Proposed Turkey Point Units 6 and 7  
Docket Nos. 52-040 and 52-041  
FPL Revised Response to NRC RAI No. 02.05.02-3 (eRAI 5896)  
L-2013-305 Attachment 2 Enclosure A Page 1 of 3

**NRC RAI Letter No. PTN-RAI-LTR-037**

**SRP Section: 02.05.02 - Vibratory Ground Motion**

**NRC RAI Number: 02.05.02-4 (eRAI 5896)**

Figure 8. Shear Wave ( $V_s$ ) and Compression Wave ( $V_p$ ) Velocity Profiles for Sonic Log PBF-12

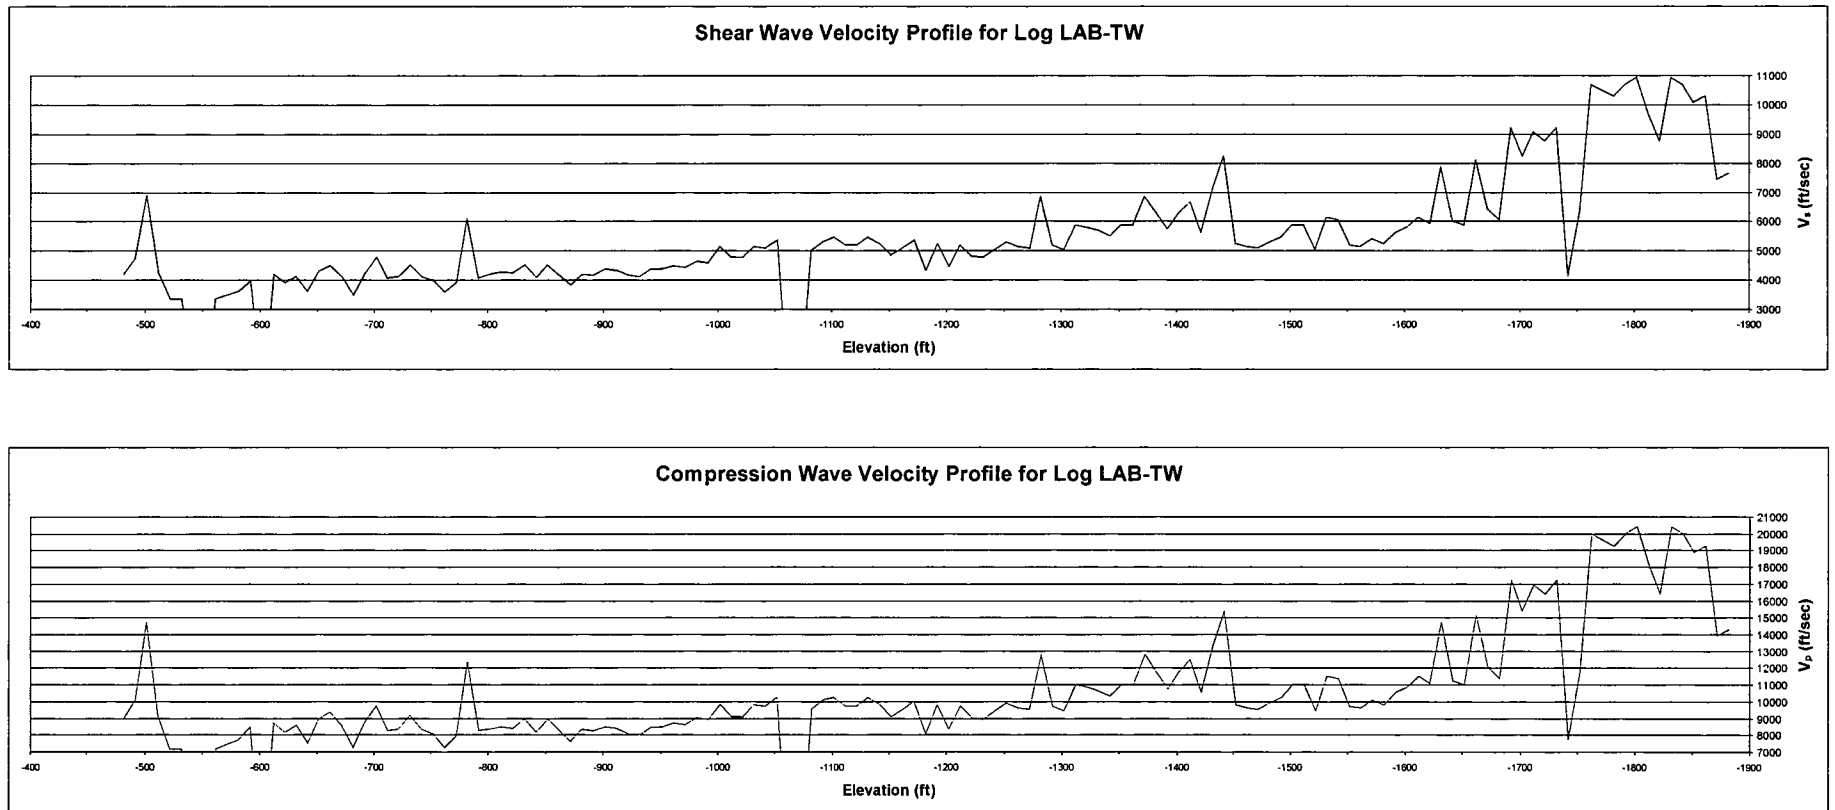
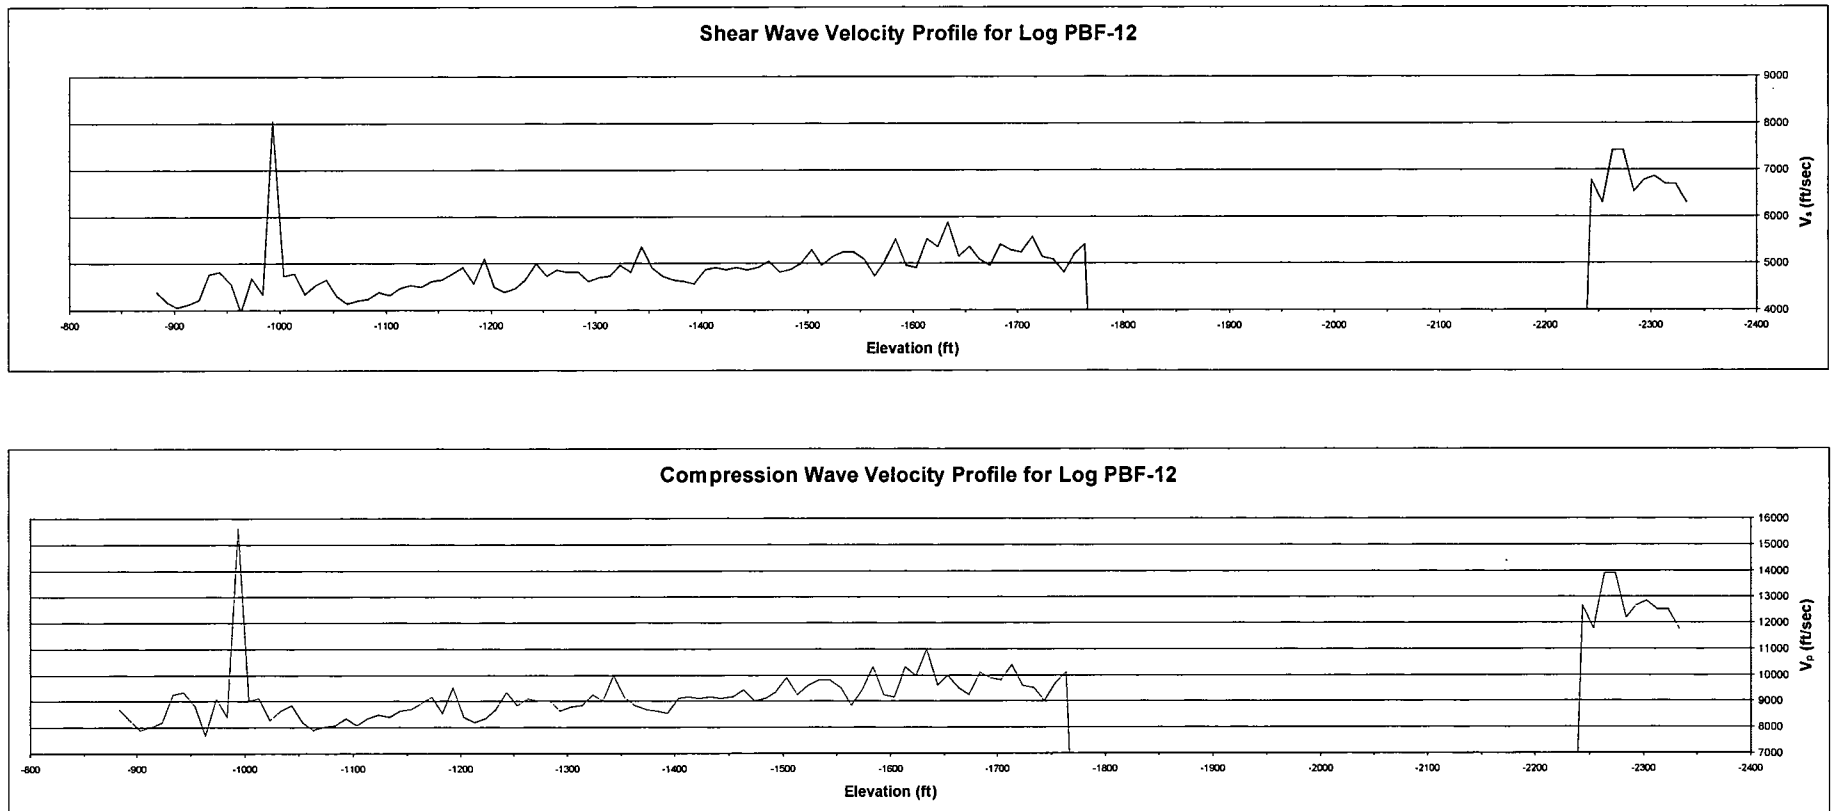
FSAR Subsection 2.5.2.5.1 states that P-wave velocities from eight deep wells were used to develop the deeper (>636 ft) sections of the site response model. The wells that provide the P-wave velocity information are approximately 100 km to 180 km away from the site. In accordance with Regulatory Guide (RG) 1.208, "A Performance-Based Approach to Define the Site-Specific Earthquake Ground Motion", please provide:

- a. additional information on the applicability of seismic velocity information obtained at such great distances to the Turkey Point site. How was the variation in geology considered in these projections?
- b. individual velocity profiles for each of the eight wells used in estimating the average profile shown in FSAR Figure 2.5.4-211
- c. further details on how larger uncertainties in deeper layers' thicknesses/depths are taken into account in the randomization of the site profile

Sonic logs 0001, 0002, 0005, 0007, 0008 and 0010 (files purchased from the Florida Geological Survey Division of Oil and Gas) were derived from wells located approximately 66 miles (approximately 106.2 kilometers), 62 miles (approximately 100.0 kilometers), 81 miles (approximately 130.4 kilometers), 110 miles (approximately 177.0 kilometers), 82 miles (approximately 132.0 kilometers), and 71 miles (approximately 114.3 kilometers) from the FPL Turkey Point site, respectively (FSAR Figure 2.5.4-210). The measurements recorded by the probe at these locations were depth, expressed in feet below the drill rig's Kelly bushing, and the interval travel time ( $\Delta T$  ( $DT_p$ )) expressed in microseconds ( $10^{-6}$  seconds) per foot. The logs were initiated at an upper depth of 3,610 to 4,100 feet (El. -3,555 to -4,059 feet NAVD 88) below each drill rig's Kelly bushing and terminated at a lower depth of 11,600 to 11,920 feet (El. -11,564 to -11,879 feet NAVD 88) below Kelly bushing.

Sonic logs LAB-TW and PBF-12 (Reference 1) were derived from wells located approximately 115 miles (approximately 185.1 kilometers) and 64 miles (approximately 103.0 kilometers) from the Turkey Point site, respectively (FSAR Figure 2.5.4-210). The measurements recorded by the probe at these locations were depth, expressed in feet

- a) The well locations with the sonic logs used for this analysis are shown on FSAR Figure 2.5.4-210. FSAR Figure 2.5.1-232 shows a north-south regional geologic cross section (Section E-F) through the Upper Mesozoic and Lower Cenozoic rocks in southern Florida. Point 39 on the cross section (and on the Inset Map on FSAR Figure 2.5.1-232) is the closest location on the regional geologic cross section to the majority of the sonic log locations on FSAR Figure 2.5.4-210. The distance from Point 39 to the Turkey Point site is about 80 miles (128.7 kilometers). Based on the review of publications (FSAR Subsection 2.5.1 References 374, 377, 378, and 397), regional geologic cross sections (FSAR Figures 2.5.1-232, 233, 235, and 236) and the sonic logs (0001, 0002, 0005, 0007, 0008, 0010, LAB-TW and PBF-12), there appears to be relatively little variation, on a regional scale, in the stratigraphy of the upper 6,000 ft between the Point 39 area and the Turkey Point site. Based upon this review the stratigraphic units generally show less variation with increasing depth. Therefore, it is reasonable to assume that the lack of stratigraphic variation on the scale shown in FSAR Figure 2.5.1-232 continues below 6,000 feet. The stratigraphic information and shear wave velocity data, which is calculated from Poisson's ratio and interval travel time derived from the sonic logs, were migrated down the gentle regional dip from the locations of the wells shown on FSAR Figure 2.5.4-210 to the Turkey Point Units 6 & 7 site. Geologic variations, where they exist, are most likely due to facies changes within the gross stratigraphic units. This regional geology-based approach is a reasonable means for developing a stratigraphic and shear wave velocity column for the stratigraphic units below the deepest site borings. This approach provides a technical basis for the development of the deep portion of the site response model. Variations in both unit thickness and material properties, that might be the result of facies changes within stratigraphic units, are accounted for by the randomization process described in part c of this RAI response.

**Figure 1. Seismic Sources from the U.S. Geological Survey's 2008 National Seismic Hazard Mapping Project  
(Petersen et al. 2008 FSAR Reference 300)**

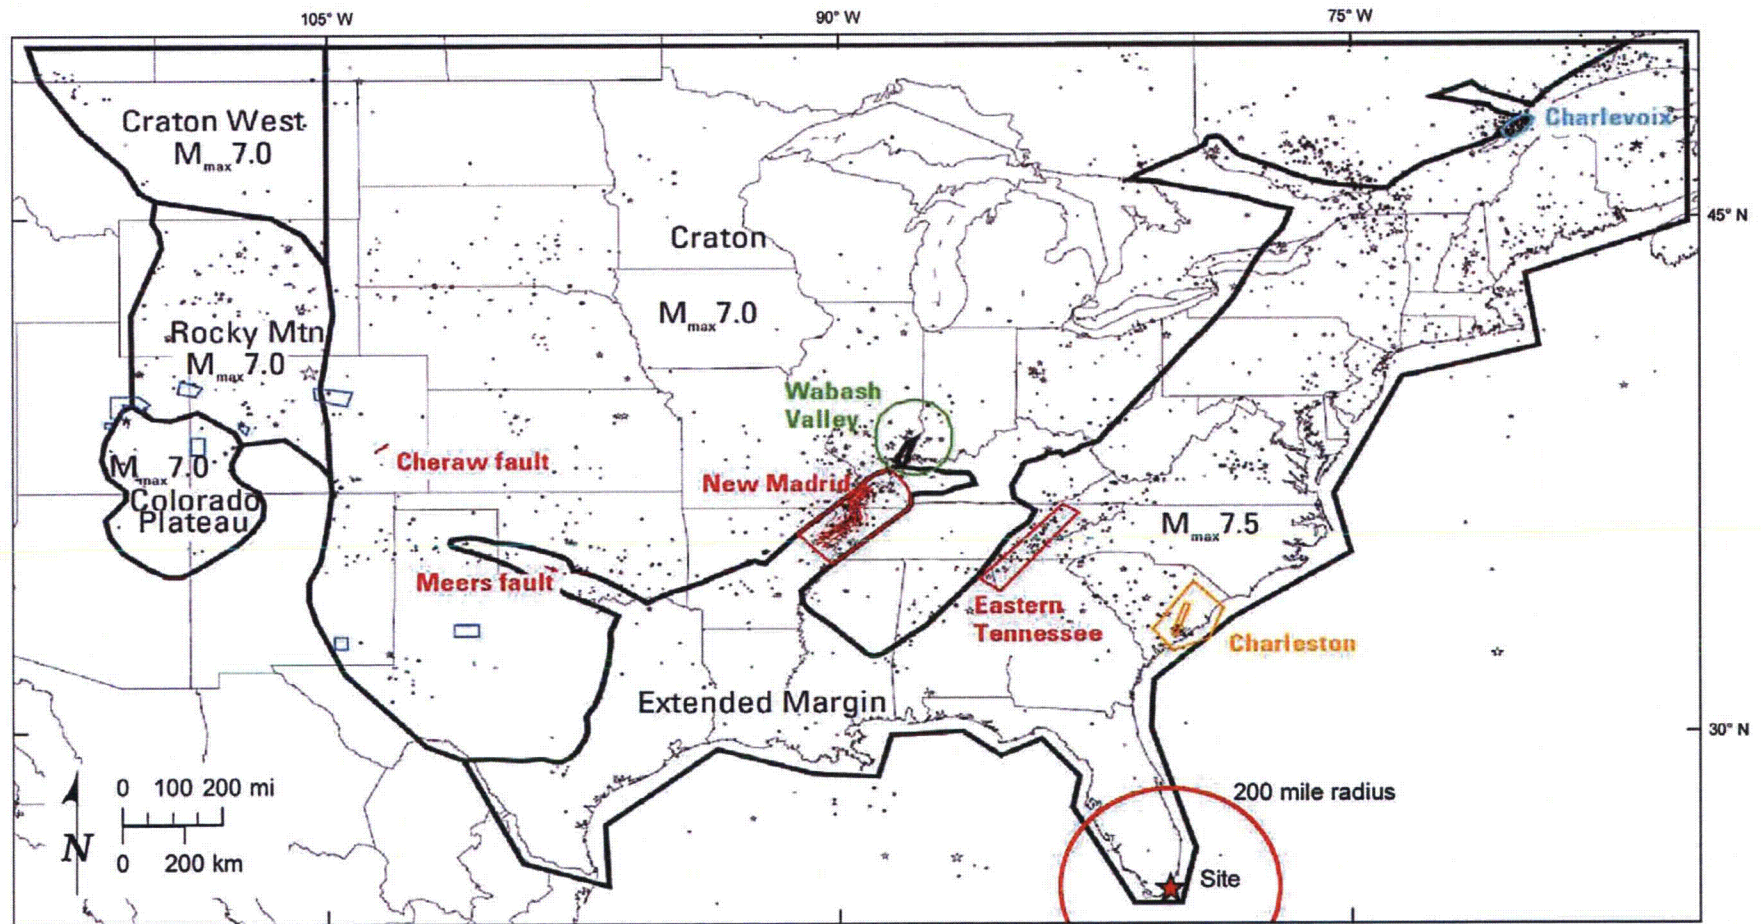
The FSAR does not list the USGS national seismic hazard map project as a potential source for EPRI seismic source model updates. The USGS regularly updates its own national seismic hazard maps using the most recent data and information. Within the last decade, the USGS published two comprehensive national seismic hazard reports in 2002 and 2008. RG 1.208 indicates that existing seismic source models should be evaluated in light of more recent data and evolving knowledge. Please discuss why the USGS national seismic hazard maps and model parameters are not discussed as potential studies to be considered in updating the existing EPRI seismic source geometries and/or model parameters.

A new discussion of the USGS National Seismic Hazard Mapping Project (NSHMP) will be added to the FSAR. The USGS NSHMP (FSAR Reference 300) characterizes seismic sources throughout the continental United States using multiple classes of earthquake source models. The general approach used by the USGS for modeling distributed seismicity in the Central and Eastern United States (CEUS) is based on gridded, spatially smoothed seismicity in large background zones. Seismic sources within the CEUS most relevant to the Turkey Point Units 6 & 7 site are modeled with: (1) a regional uniform background source model dividing the Extended Margin of the CEUS from the Craton; (2) special zones accounting for variability in catalog completeness, seismicity, maximum magnitude, and b-value, such as the uniform source zones for the Eastern Tennessee and New Madrid seismic zones; and (3) finite fault sources, such as those included for the New Madrid and Charleston seismic sources.

The 2008 NSHMP earthquake sources are depicted in Figure 1. Significant changes from the 2002 NSHMP (FSAR Reference 251) model of seismic hazard in the CEUS include: (1) uncertainty in the maximum magnitude (Mmax) assigned to Mmax zones (e.g., Extended Margin); (2) revised geometry of the Charleston seismic source zones; and (3) revised magnitudes, rates, and geometry for the New Madrid seismic source. As a result of these updates, the 2008 NSHMP characterizes Mmax for the Extended Margin and Craton as weighted distributions ranging between M7.1 - 7.7 and M6.6 - 7.2, respectively. The two areal zones defining the Charleston source are both assigned Mmax distributions of M6.8 - 7.5 with a recurrence interval of 550 years, unchanged from the 2002 NSHMP (FSAR Reference 251). The Charleston seismic source updates from the NSHMP (FSAR Reference 300) are discussed in Subsections 2.5.2.4.4.2.2 and 2.5.2.4.4.2.3.

The NSHMP model only covers a small portion of the site region (Figure 1) and does not include seismically active areas in the southern part of the site region and beyond, such as Cuba and the North America-Caribbean plate boundary that contribute to the seismic hazard in southern Florida. Therefore, a direct comparison between the NSHMP SSC model and the FSAR SSC model is not presented in the FSAR.
